**13 Apr 2023**

TO: City Council

FROM: Jim Light, District 1  
Jim Hannon, South Bay Bicycle Coalition+

SUBJECT: Improvements to Bicycle Path in Pier Parking Lot Area

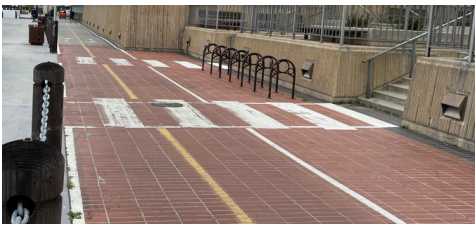
Unfortunately, when installed the blinking lights were hardwired to be on constantly with no actuation or timing mechanism. **As predicted by the 2016 Staff Report, bicyclists ignore these lights because they are never off even when pedestrian traffic is sparse or non-existent.**

- A) Reconfigure the yellow walk bike lights to flash during anticipated higher pedestrian volume. We concur with the times recommended by the Harbor Commission. This would encourage cyclists to comply as it is reasonable and justifiable.
- B) Continue the green paint scheme of the bike track through the entire pier area. This would clearly indicate to bicyclists, pedestrians and motorists the intended route of the bike path through the whole area.
- C) Paint white crossing stripes at all places where pedestrians cross the bike path from the end to bike track to the south end of the pier parking structure by the southern restroom.
